CITY OF ALBUQUERQUE

RE: Lot 12 Block 4 Unit 22 SAD 228 6411 Canavio Pl NW Grading and Drainage Plan Engineers Stamp Date 6/23/2022 (D10D003D12)

Based upon the information provided in your submittal received 6/23/2022, this plan is approved for Grading Permit.

6-22-22 6411CANAVIO.DWG SHEET# C1

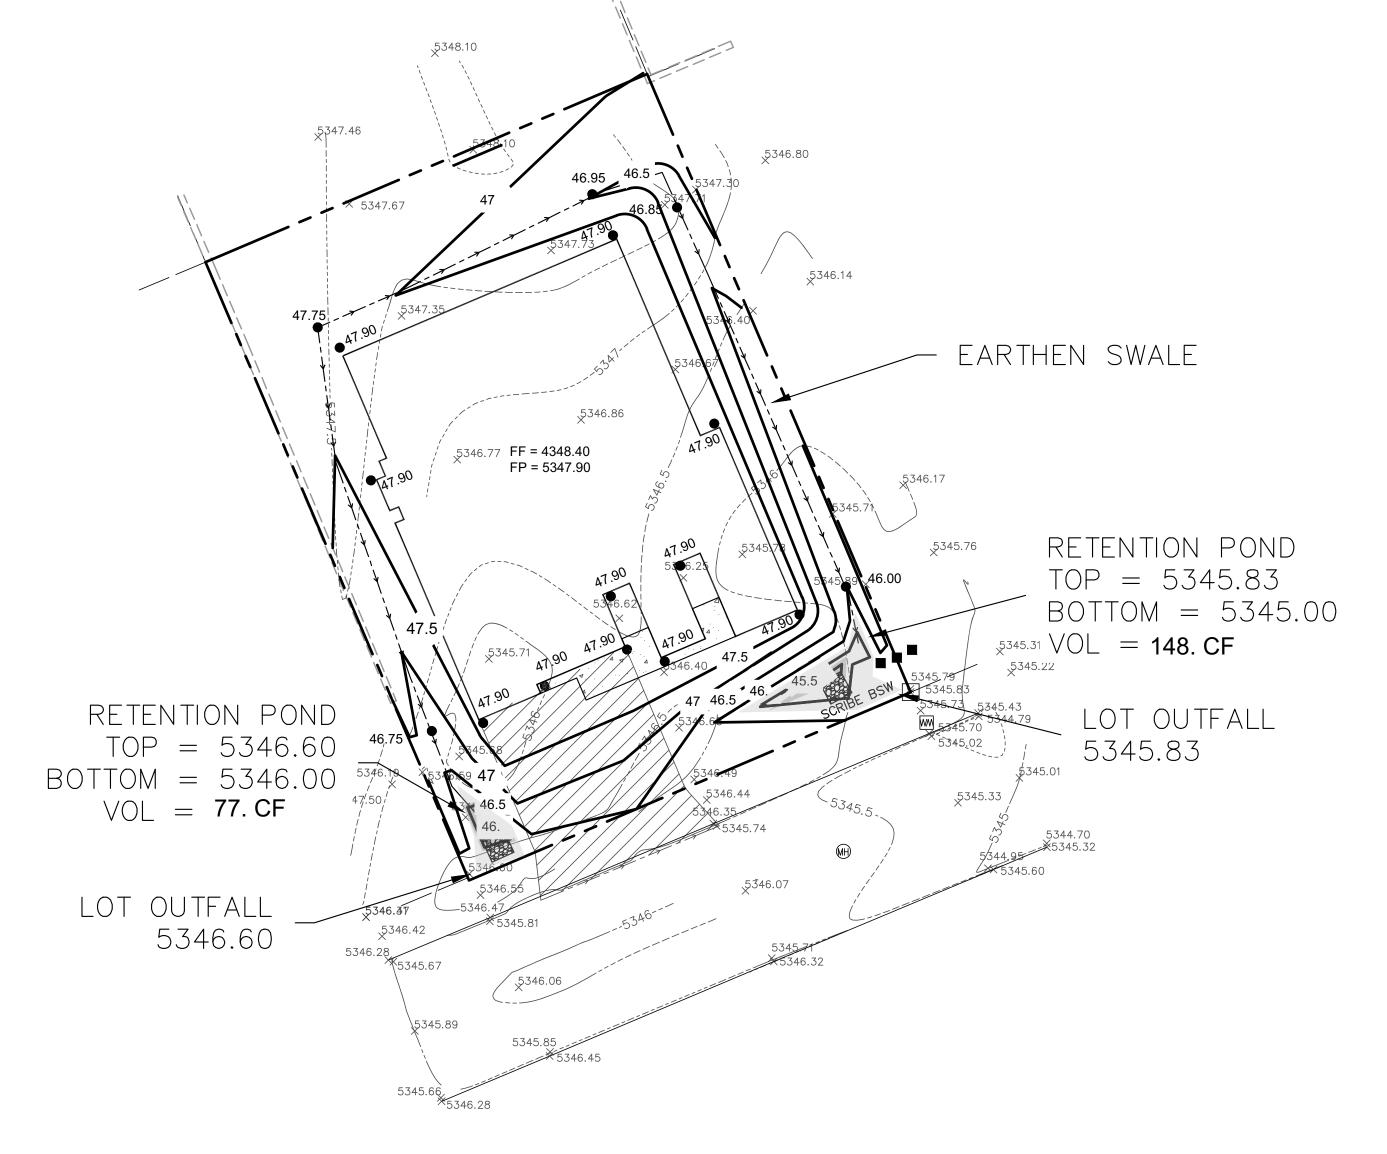
Prior to Building permit approval a Pad Certification will be required, provided by the Engineer or a registered Land Surveyor.

Advise the owner contractor not to use dirt as a ramp to climb the curb, use lumber or crusher fines for this purpose.

Reiterate to the Owner/Contractor that a separate permit for a garden/retaining wall must be obtained with the approved G&D plan and Pad Certification. Also, if a swimming pool is to be placed the grading and drainage plan will change and will need to be resubmitted.

Prior to Certificate of Occupancy release, Engineer Certification per the DPM checklist is required.
